**PLANNED UNIT DEVELOPMENT &
PLANNING APPROVAL STAFF REPORT****Date: December 1, 2011****NAME**

St. Ignatius Parish

AREA OF PROPERTY1 Lot / 13.3 \pm acres**CONTEMPLATED USE**Planning Approval to amend a previously approved
Planning Approval allowing an existing church and school
in an R-1, Single-Family Residential District, and Planned
Unit Development Approval to amend a previously
approved Planned Unit Development allowing multiple
buildings on a single building site to include a future
outdoor plaza, classrooms, parish hall, kitchen, cafeteria
and parking facilities.**TIME SCHEDULE
FOR DEVELOPMENT**

SITE PLAN

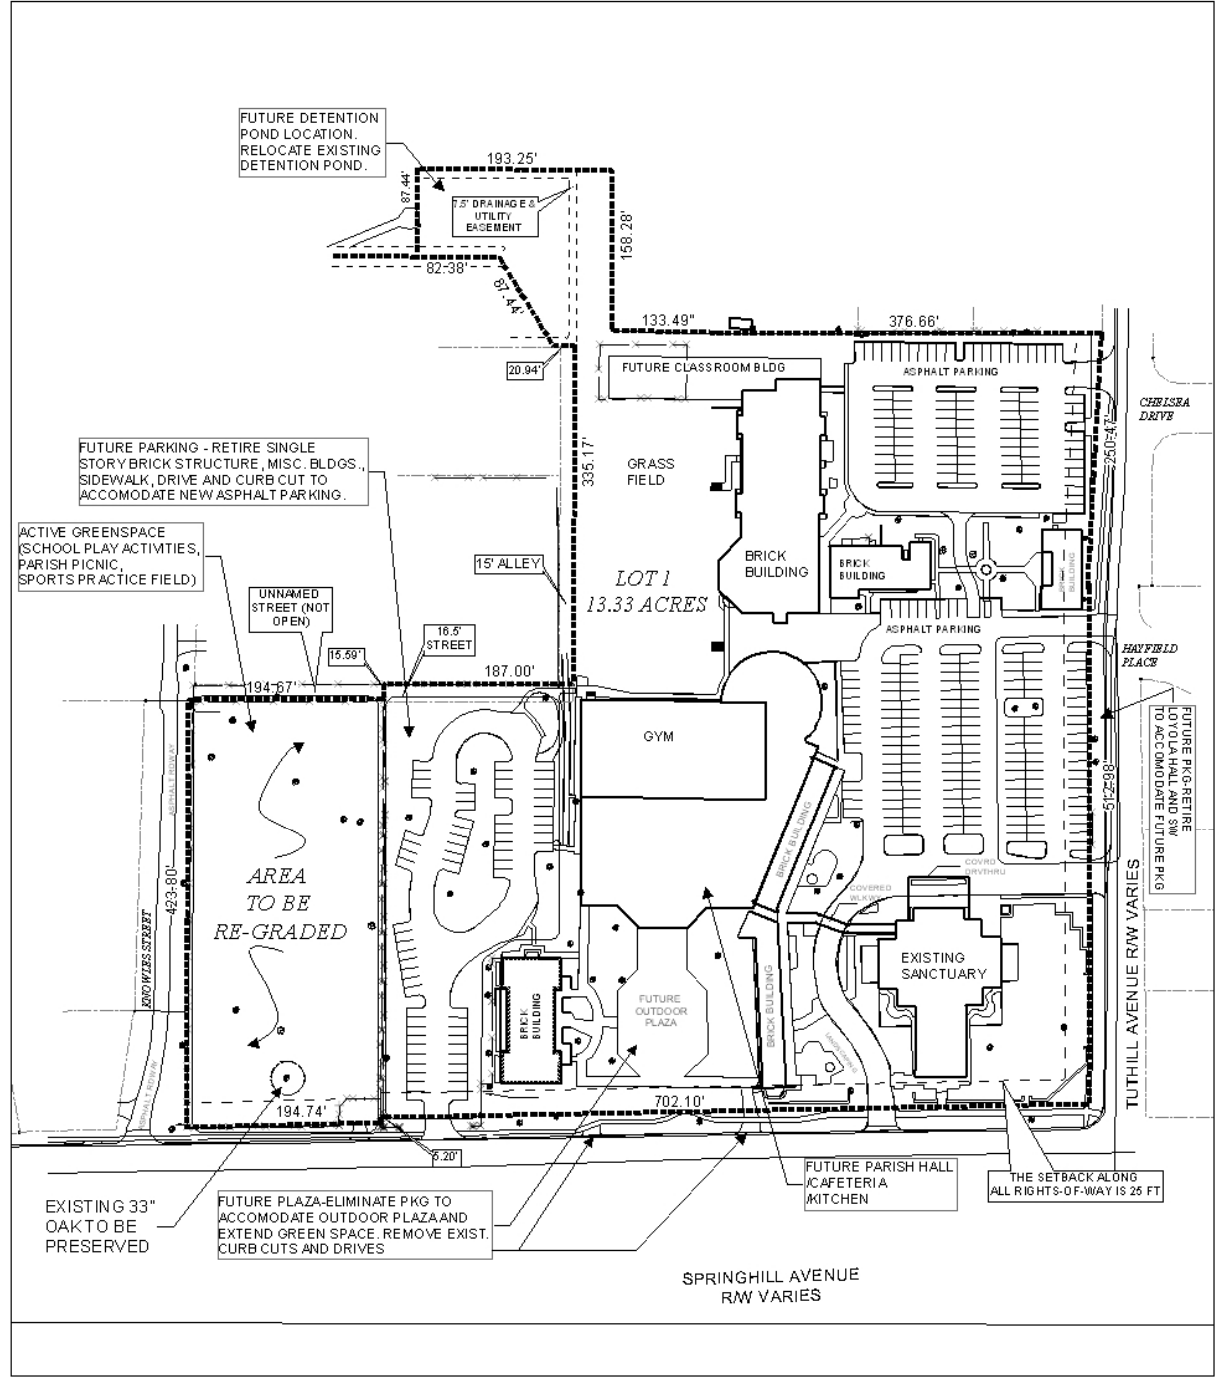
The site fronts onto two minor streets, Tuthill Lane and Knowles Street, and Spring Hill Avenue, a proposed major street. The site also abuts two segments of an unnamed street or alley. Dedication was required as part of the 2010 approval, and while shown on the final, recorded plat, is not reflected on the site plans. The site plans should be revised to reflect right-of-way dedication along both Spring Hill Avenue and Knowles Street.

The 25-foot minimum building setback line is not fully depicted on the site plans. The site plans should be revised to depict the 25-foot minimum building setback line from all public rights-of-way, and should reflect any required dedication.

Information on the site plan regarding parking requirements indicates that parking for 52 teaching stations is required, and that parking for 600 pew seats is required. It is not clear if the teaching station information is for existing only, or includes proposed new classrooms. The parking ratio information lists a total parking requirement of 222 parking spaces: there are 196 existing spaces, and an additional 126 spaces are proposed for a total of 322 parking spaces.

The new parking proposed fronting Tuthill Lane, across from single-family residential properties, should include a 3-foot high wall or vegetative buffer, in compliance with Section 64-6.A.3.i. of the Zoning Ordinance. Furthermore, any lighting of the parking area or the site must comply with the lighting requirements of the Zoning Ordinance: lighting cannot shine onto adjacent residences or into the public right-of-way, and must be provide for parking areas containing 10 or more parking spaces that are utilized at night (Sections 64-6.A.3.c. and 64-4.A.2. of the Zoning Ordinance).

The proposed active greenspace will be across streets / public rights-of-way from existing single-family residences, specifically those located along Knowles Street. While the Knowles Street right-of-way appears heavily vegetated, the greenspace should still be bounded by a buffer in the form of a 6-foot high wooden privacy fence, located 25-feet from the right-of-way edges for Spring Hill Avenue and Knowles Street (after dedication along both streets), and 10-feet from the North property line.

To protect adjacent residences, the PUD and Planning Approval site plans should depict a 10-foot setback buffer along the property lines which do not abut Tuthill Lane, Spring Hill Avenue or Knowles Street. Where the property abuts unopened rights-of-way, any new buffer fences should be set back at least 10-feet if they are more than 3-feet in height.

It should be pointed out that the site plan does not reflect the gated entrance located on Tuthill Lane – the entrance is shown, but the fact that it is gated is not indicated. The site plan should be revised to accurately reflect which entrances are gated, and the location of walls, or other structures. Also, it appears that the existing fence along Knowles Street is topped with strands of barbed-wire: such fencing is not allowed in residential districts without variances, thus the barbed-wire topping should be removed, or a variance should be requested.

- 1) revision of the site plan to reflect dedication of right-of-way along Spring Hill Avenue (50-feet from centerline) and Knowles Street (25-feet from centerline), including a corner radius;

- 2) revision of the plat and site plan to depict and label the 25-foot minimum building setback from all open public rights-of-way;
- 3) revision of the site plan to depict and label a 10-foot minimum building setback and buffer from all other property boundaries that are not open public rights-of-ways;

- 4) revision of the site plan to depict any existing or proposed gated driveway entries or walls;
- 5) provision of a 6-foot high wooden privacy fence for the greenspace area at the 25-foot street setback and 10-foot buffer setback lines on the South, West and North sides, removing the existing fence along Spring Hill Avenue with permits, prior to the use of the space;
